NABCO ENTRANCES TECHNICAL BULLETIN

Clarification of Surface Applied 1175 Dimensions

Bulletin Number: **6**

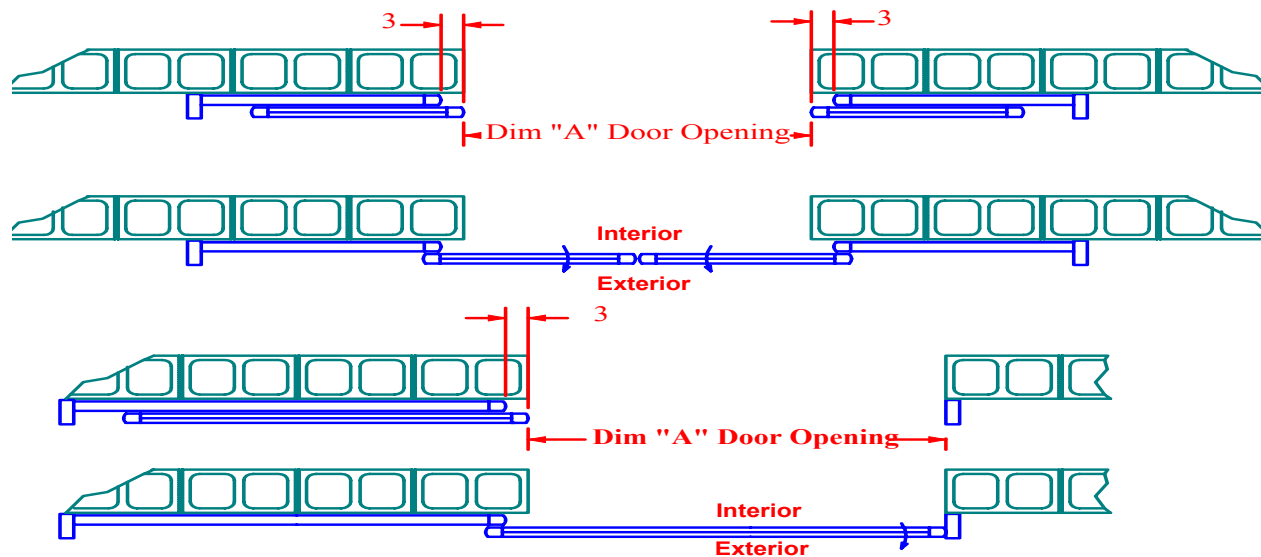
Because our cutting lists and order forms for standard size units are set up for even dimensioned openings for *any* of our units, it is simpler to maintain that terminology for surface applied units. Hence, a 42" single will have a 42" slide opening and 45" breakout opening (from the above drawing). This layout ensures that your customer will get the maximum usable door opening from his building opening.

However, the structural member or wall material that the unit is applied to will be visible at the back 3" of the door. If this is objectional to the customer, order a door opening that is 3" smaller than the opening in the building for a single or 6" smaller than the opening in the building for a bi-part. Please note that in this type of layout, the door will protrude into the opening by 3 inches.
